PCN# : P685AAB
Issue Date : Aug. 31, 2016

Information Only Notification

TO263 Carrier tape

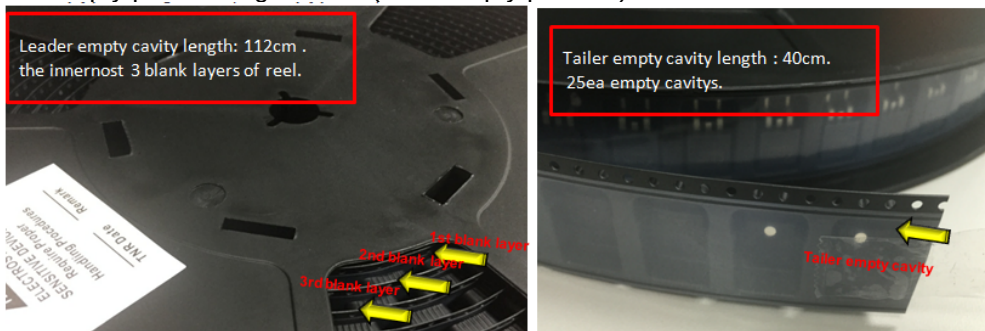
Description of Change (From) :

Lead empty length: 72cm(45ea empty pockets, the innermost 2 blank layers of reel).

Tail empty pocket length: 80cm(50ea empty pockets).

The change is to mitigate lead deformation during product transportation.

Description of Change (To) :

Lead empty length: 112cm(70ea empty pockets, the innermost 3 blank layers of reel).

Tail empty pocket length: 40cm(25ea empty pockets).
